5-18-0930 (GRAHAM PROPERTY MANAGEMENT, LLC)

FEBRUARY 8, 2024

EXHIBITS

SUBJECT: Updated ESHA Determination for 217 Vista Marina, San Clemente
(Orange County)

Figure 2. Exhibit 3, "Vegetation/Impact Map" from GLA's 2018 'Biological Technical Report, 217 Vista Marina, City of San Clemente, Orange County, California'.

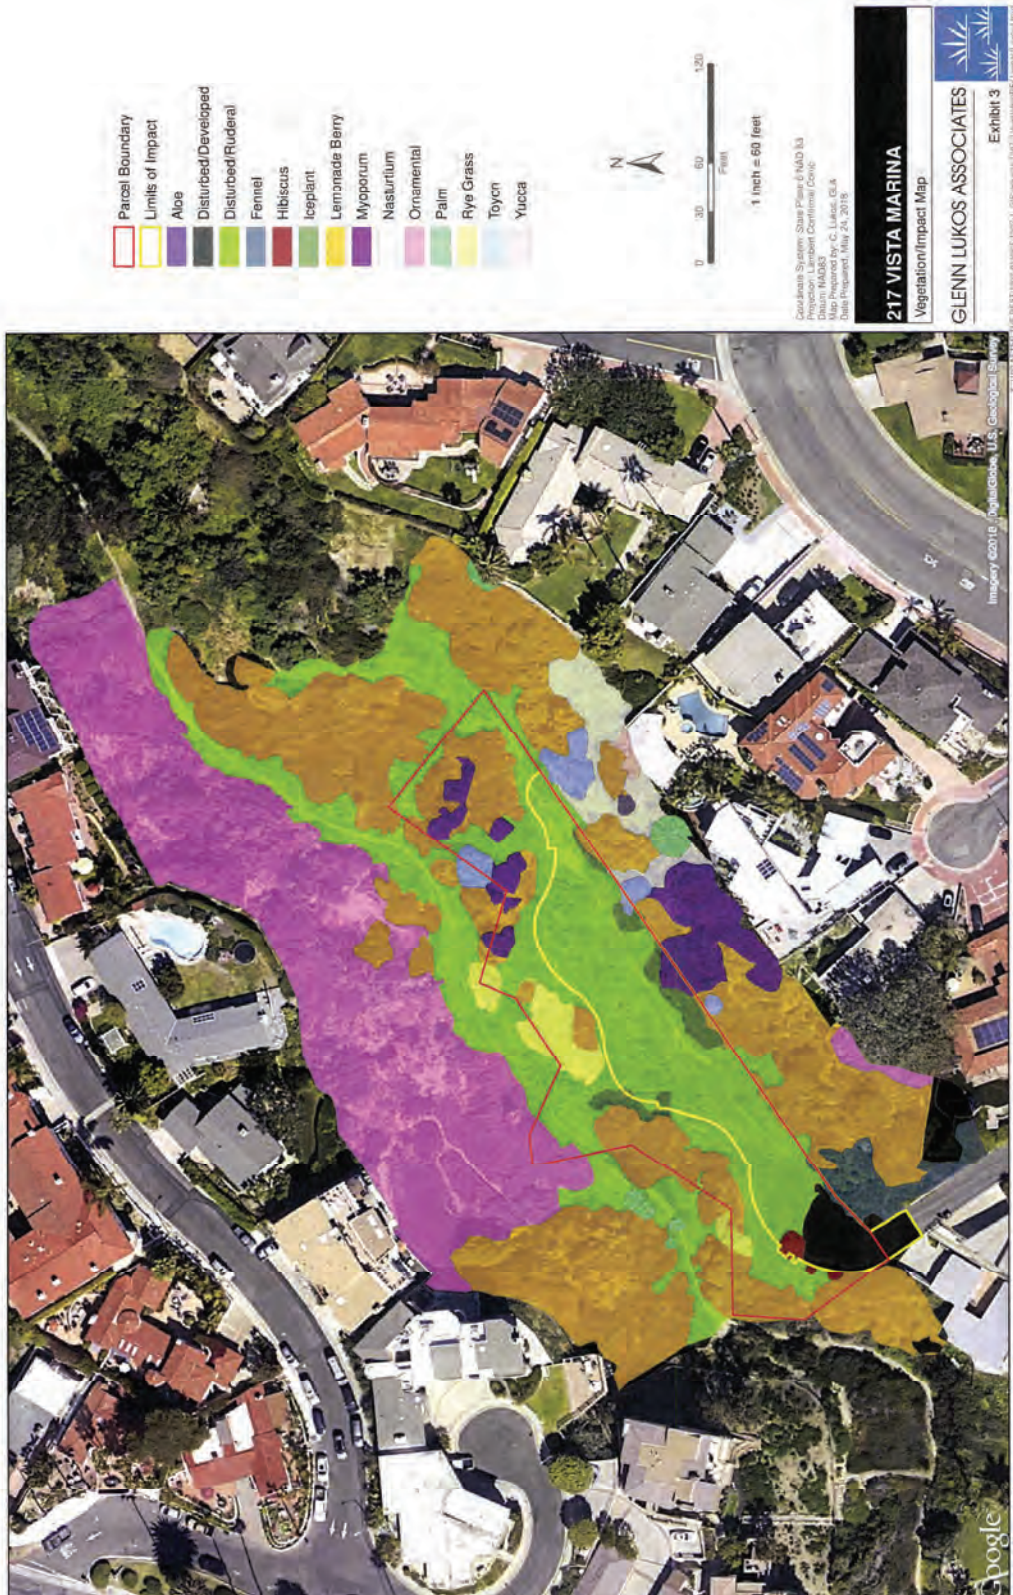
GLA also conducted focused plant surveys to map the vegetation on the site on March 29 and April 27, 2018. GLA identified and mapped vegetation according to the habitat descriptions provided by the *Manual of California Vegetation, Second Edition*. They mapped the vegetation communities to the thousandth of an acre, or 43.6 square feet. GLA mapped two special status native vegetation communities: 0.169 acres of lemonade berry scrub and 0.035 acres of giant wild rye grassland. 0.007 acres of native Toyon scrub (*Heteromeles arbutifolia*) was also mapped, and a single individual California boxthorn (*Lycium californicum*), a 4.2 listed California Native Plant Society (CNPS) rare plant, was identified on the extreme western end of the site. GLA also mapped patches of non-native and invasive species including myoporum, acacia, fennel, and iceplant (Figure 2).

Based on GLA's 2018 and 2023 vegetation maps of the subject site and vicinity (Figures 2 and 3), which have remained virtually the same, I have identified four patches (also referred to as stands) of lemonade berry scrub and one patch of Giant Wild Rye Grassland (Figure 4). Stands (patches) are the unit that the CDFW and the CNPS map for delineating unique vegetation communities. According to the March 7, 2023 'CDFW-CNPS Protocol for the Combined Vegetation Rapid Assessment and Relevé Field Form'⁴:

Figure 3. Exhibit 1, "Vegetation Groupings with 50' Wall Buffer" from GLA's 2023 Technical Memorandum 'Additional Considerations Regarding Vegetation Alliances at 217 Vista Marina, San Clemente'.

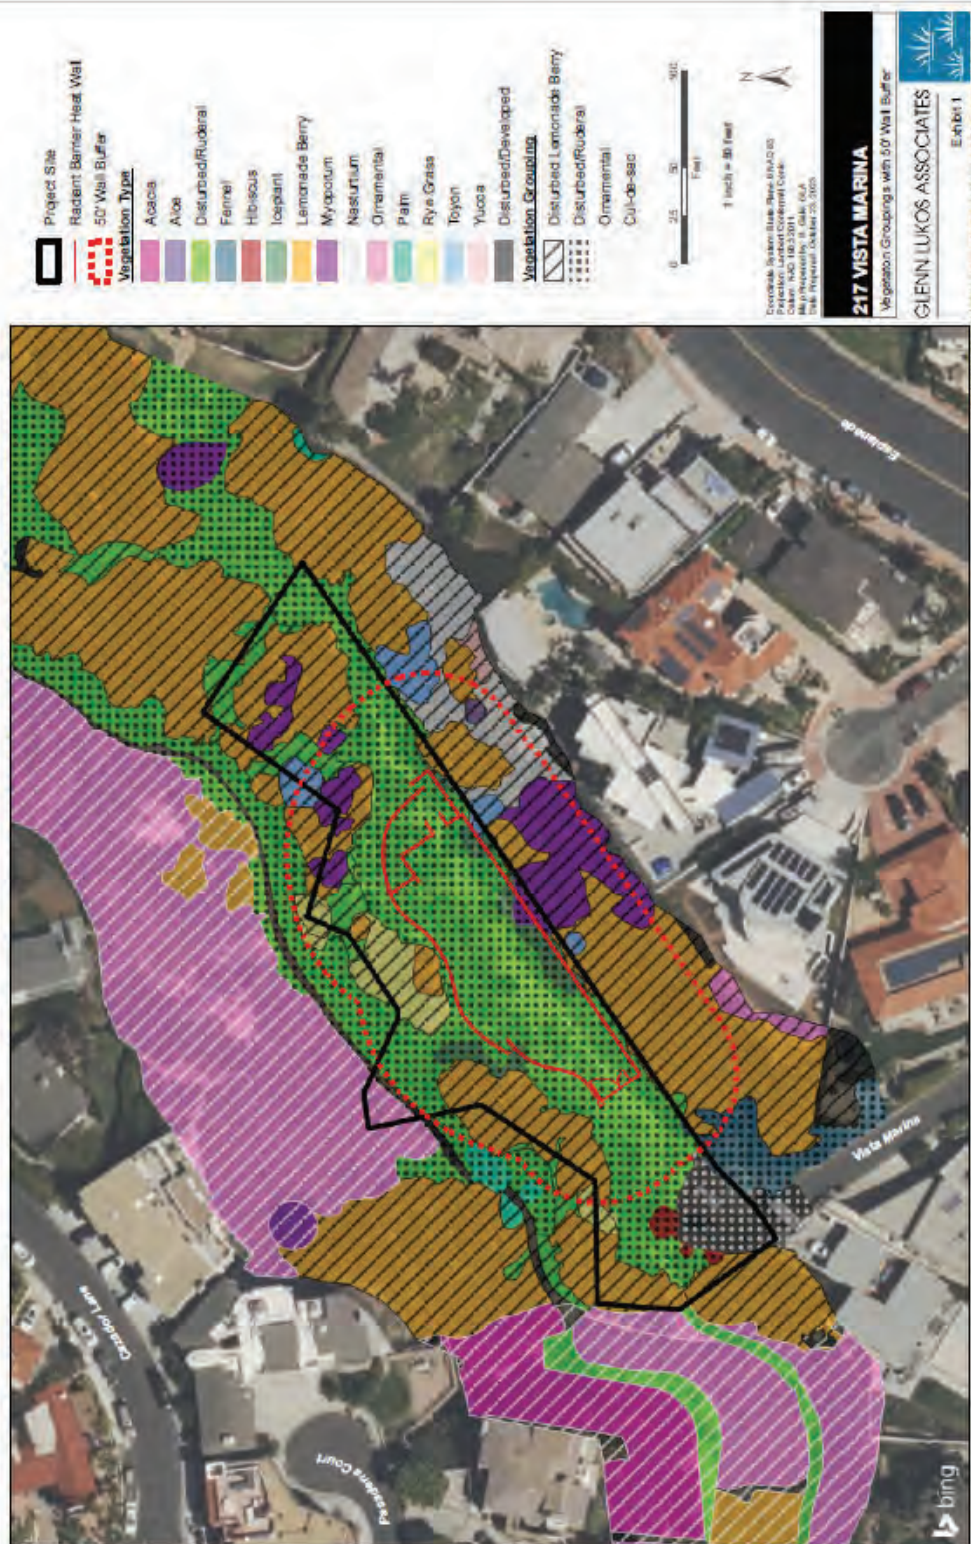
On October 23, 2023, Mr. Bomkamp submitted another technical memorandum, this time prepared for Mark McGuire, whose subject was *Additional Considerations Regarding Vegetation Alliances at 217 Vista Marina, San Clemente*. In this memorandum, Mr. Bomkamp revised his vegetation map to identify the lemonade berry scrub stands on the site as “disturbed lemonade berry scrub” instead of “lemonade berry scrub” because he notes that the areas mapped as lemonade berry are not 100% lemonade berry bushes but include non-native species such as myoporum, acacia, aloe, jade, and other non-native vegetation (Figure 3).

Figure 5. *Rhus integrifolia* Shrubland Alliance (Lemonade berry scrub) and *Leymus condensatus* Herbaceous Alliance (Giant wild rye grassland) ESHA stands protected by 50-foot buffers.

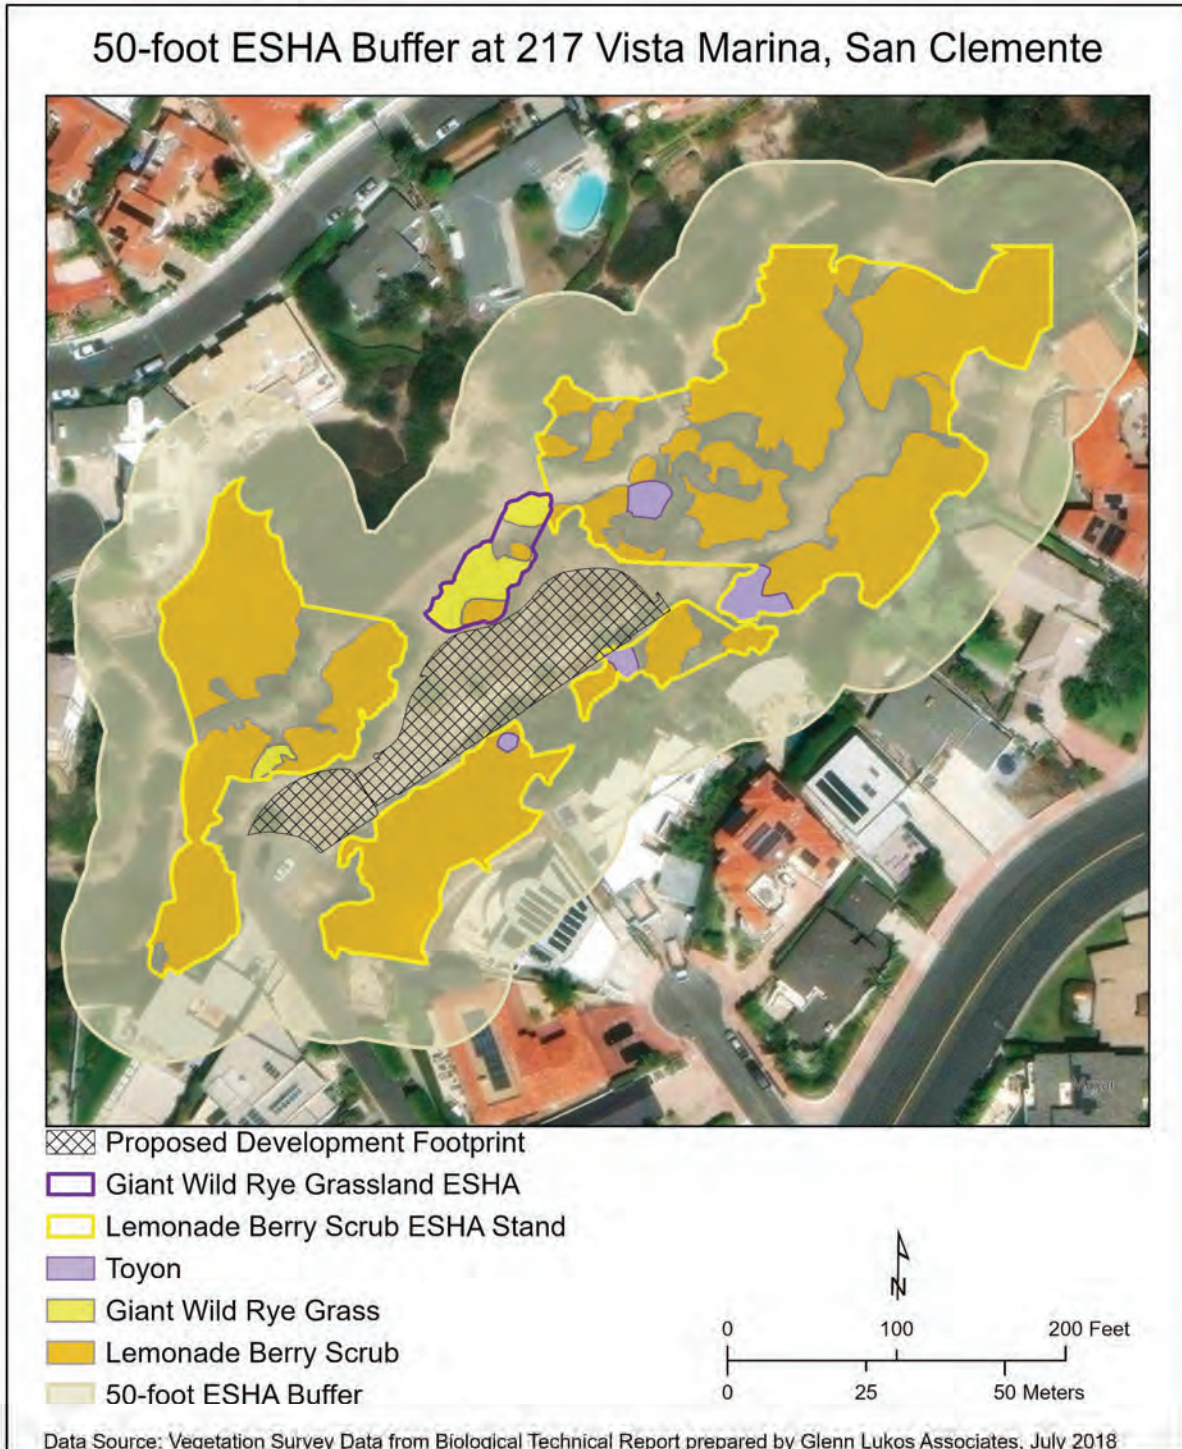
While the San Clemente LUP buffer policy calls for a 100-foot buffer, I find that a 50-foot buffer, along with a 6-foot fire wall surrounding the development, would prevent impacts that would significantly degrade or disrupt the biological integrity and habitat values of the ESHA on this site. In the discussion above I lay out the rationale for buffers between ESHA and development and all the potential adverse activities they provide protection against. Although the wall provides some additional buffering, it is limited by the fact that the development towers over the wall, allowing some of the impacts of typical residential development, such as light and noise, to flow freely beyond the wall. Thus, the buffer should not be reduced dramatically from 100 feet. It is my professional opinion, given the subject site characteristics, that the 50-foot buffer I am recommending, in combination with a 6-foot wall, will provide a sufficient distance between proposed development and ESHA for “business as usual” activities such as native vegetation reproduction and growth, insect pollination, and other animal activities such as nesting, foraging, dispersing, and mating (Figure 5).

Figure 2. Exhibit 3, "Vegetation/Impact Map" from GLA's 2018 'Biological Technical Report, 217 Vista Marina, City of San Clemente, Orange County, California'.

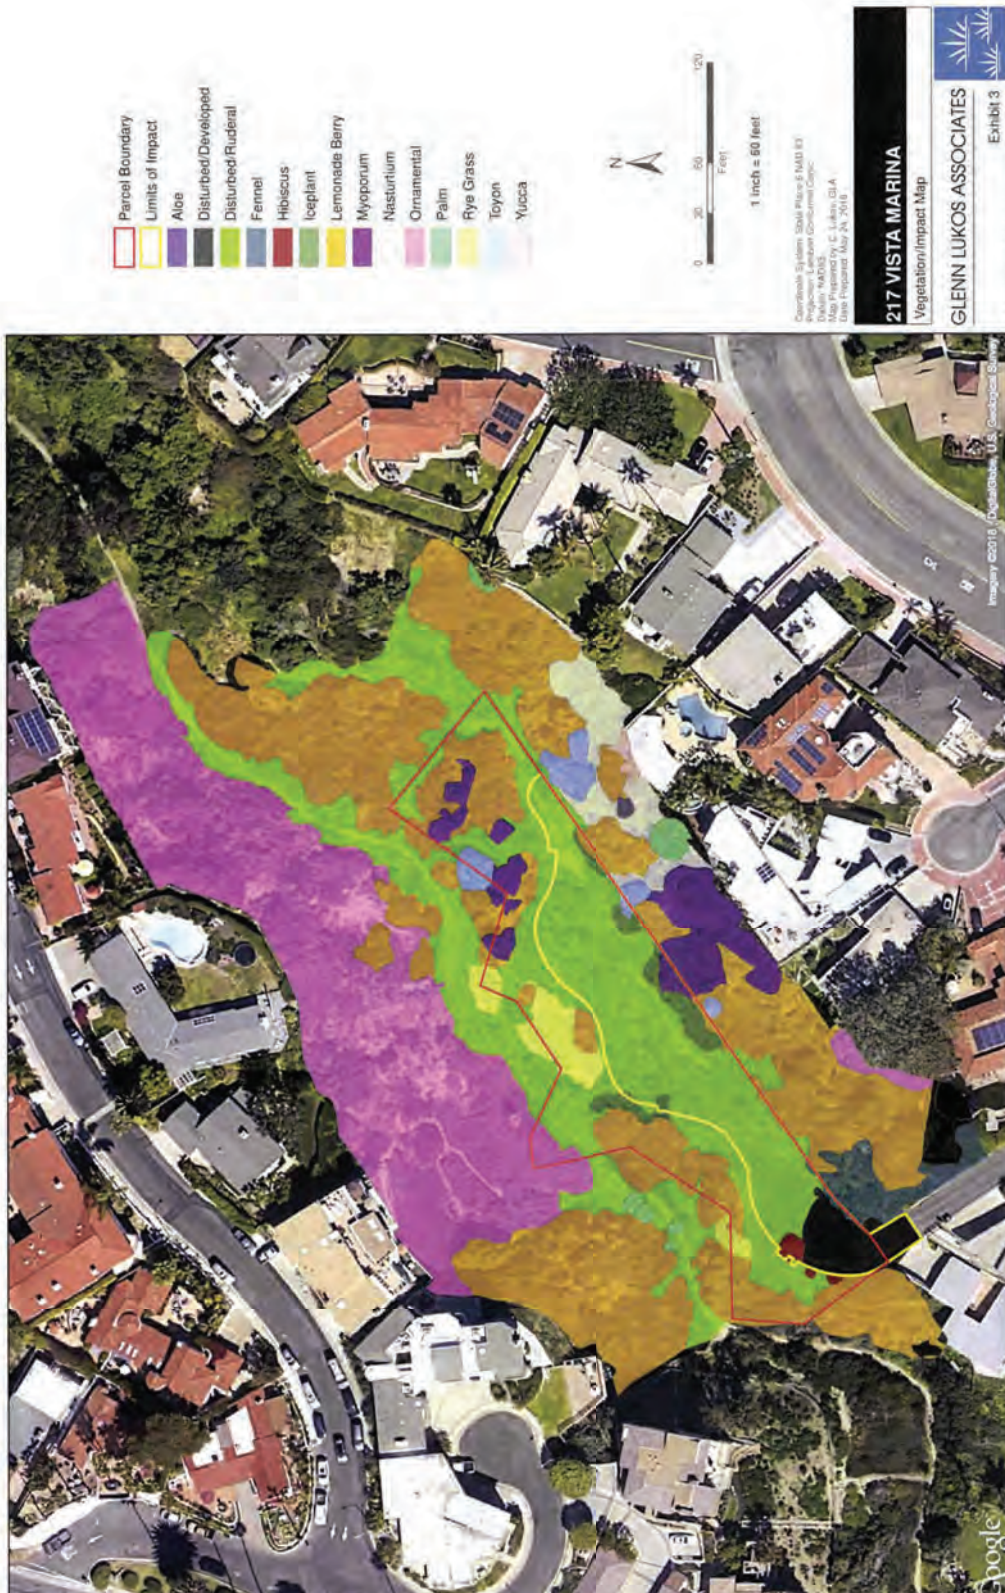
GLA also conducted focused plant surveys to map the vegetation on the site on March 29 and April 27, 2018. GLA identified and mapped vegetation according to the habitat descriptions provided by the *Manual of California Vegetation, Second Edition*. They mapped the vegetation communities to the thousandth of an acre, or 43.6 square feet. GLA mapped two special status native vegetation communities: 0.169 acres of lemonade berry scrub and 0.035 acres of giant wild rye grassland. 0.007 acres of native Toyon scrub (*Heteromeles arbutifolia*) was also mapped, and a single individual California boxthorn (*Lycium californicum*), a 4.2 listed California Native Plant Society (CNPS) rare plant, was identified on the extreme western end of the site. GLA also mapped patches of non-native and invasive species including myoporum, acacia, fennel, and iceplant (Figure 2).

Based on GLA's 2018 and 2023 vegetation maps of the subject site and vicinity (Figures 2 and 3), which have remained virtually the same, I have identified four stands of lemonade berry scrub and one stand of giant wild rye grassland (Figure 4). Stands are the unit that the CDFW and the CNPS map for delineating unique vegetation communities. According to the March 7, 2023 'CDFW-CNPS Protocol for the Combined Vegetation Rapid Assessment and Relevé Field Form'⁴:

Figure 5. *Rhus integrifolia* Shrubland Alliance (Lemonade berry scrub) and *Leymus condensatus* Herbaceous Alliance (Giant wild rye grassland) ESHA stands protected by 50-foot buffers.

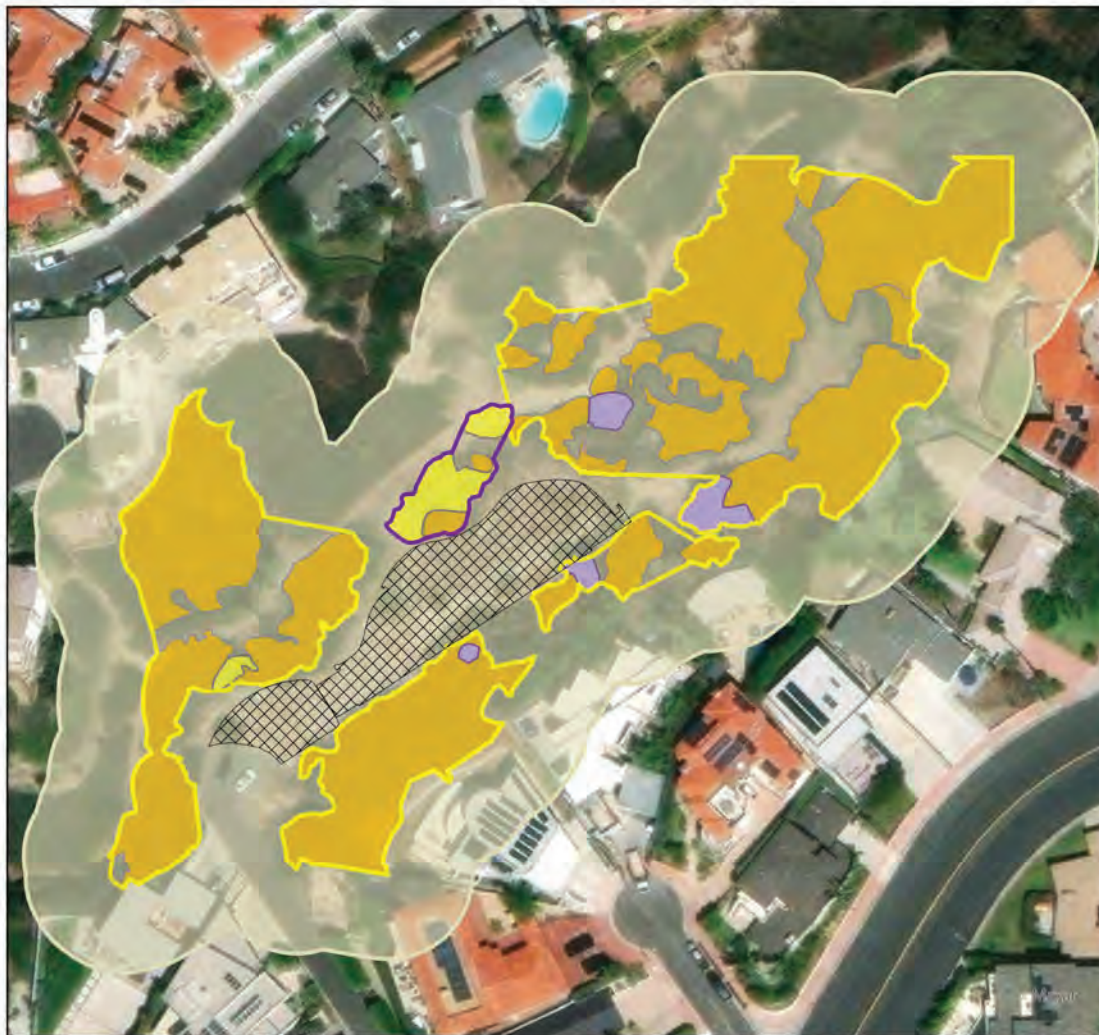
While the San Clemente LUP buffer policy calls for a 100-foot buffer, I find that a 50-foot buffer, along with a 6-foot fire wall surrounding the development, would prevent impacts that would significantly degrade or disrupt the biological integrity and habitat values of the ESHA on this site. In the discussion above I lay out the rationale for buffers between ESHA and development and all the potential adverse activities they provide protection against. Although the wall provides some additional buffering, it is limited by the fact that the development towers over the wall, allowing some of the impacts of typical residential development, such as light and noise, to flow freely beyond the wall. Thus, the buffer should not be reduced dramatically from 100 feet. It is my professional opinion, given the subject site characteristics, that the 50-foot buffer I am recommending, in combination with a 6-foot wall, will provide a sufficient distance between proposed development and ESHA for "business as usual" activities such as native vegetation reproduction and growth, insect pollination, and other animal activities such as nesting, foraging, dispersing, and mating (Figure 5).

Figure A: Canyon cross-section (see **Fig. 2** for location)

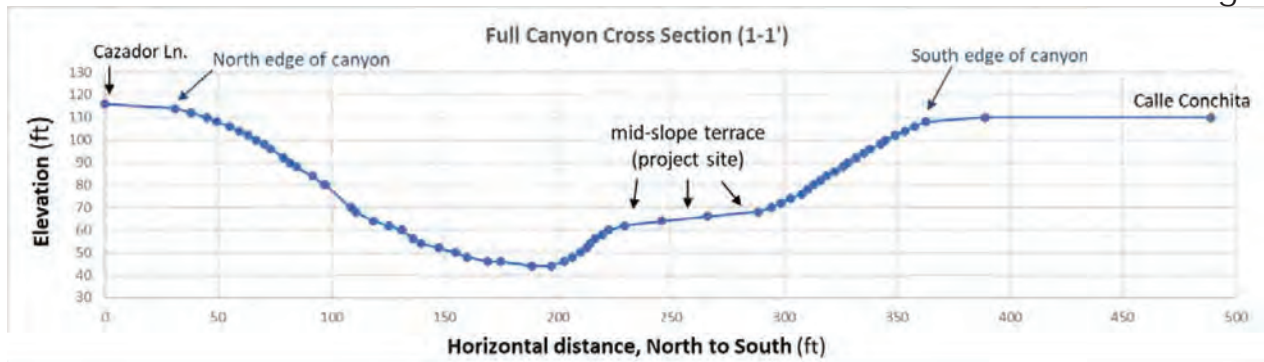
In each of these representations of the site, the geomorphic canyon edge, and the “canyon edge” that best fits the definition contained in the City LUP, is located at the top of the 30- to 40-foot-high slope immediately behind and to the south of the proposed building site, at elevations of approximately 100 to 110 feet (**Figs. A, 1-2**). This is the “upper termination” of the canyon landform, and to the extent that this top of slope is “rounded away from the canyon face”, it is still “the point nearest the canyon beyond which the downward gradient of the surface increases more or less continuously until it reaches the general gradient of the canyon.” Measured from top-to-bottom, the average gradient of the southern slope of the canyon is approximately 2.5:1 (horizontal to vertical; h:v); excluding the mid-slope terrace, the slopes both above (south of) and below (north of) the terrace have gradients of 2:1 or greater.

As can be seen in cross-section (**Fig. A**, above; also Fig. 1), moving northward from the top of the canyon (i.e., near Calle Conchita) the gradient increases quickly and ‘more or less continuously’ until it reaches the gradient of the upper slope, which matches or exceeds the general gradient of the canyon. Obviously, the gradient of the terrace on which the project would be located is much less, but I view this as a temporary hiatus or variation in the “general gradient of the canyon” rather than an indication that the terrace somehow lies outside the boundaries of the canyon. The terrace could be considered a “step” or “riser” under the LUP and Commission definitions, but it is located closer to the bottom of the canyon slope than the “top of the canyon face”, and my recommended canyon edge determination is not dependent on this part of the definition language.
